Overview

The purpose of this memo is to inform you that XC18V00 devices with the topmark "ART" are sensitive to noise when operated outside of the data sheet specification.

Figure 1 (Recommended Resistor Value)

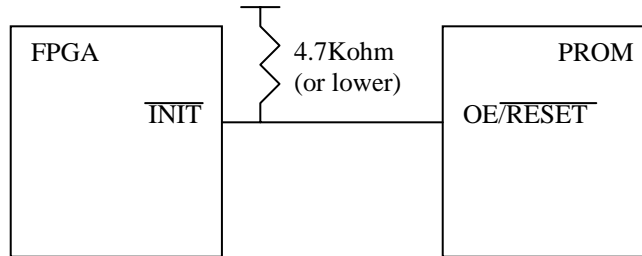
1. As specified in the data sheet, an external resistor of 4.7-Kohm (or lower) is required to quickly pull up the FPGA INIT and PROM OE/RESET# signal line. If the FPGA INIT and PROM OE/RESET# signal line rises too slowly, then system noise might corrupt the PROM's internal address counters, thus keeping the FPGA from configuring properly.
2. As specified in the FPGA data sheet, do not exceed 12-mA sink current on the FPGA DONE pin. Beware of LED driving circuits. Using DONE to drive the LED and the PROM CE# pin directly (un-buffered) exceeds this specification. This also affects the FPGA drive_done option.

1. Follow the data sheet to ensure that an external 4.7 Kohm (or lower) resistor is connected to the PROM's OE/RESET# pin and the FPGA's INIT pin. Ensure that the FPGA TICCK specification is met (500ns). This translates to a Trise and Tfall time of 500ns for the PROM's OE/RESET# signal.
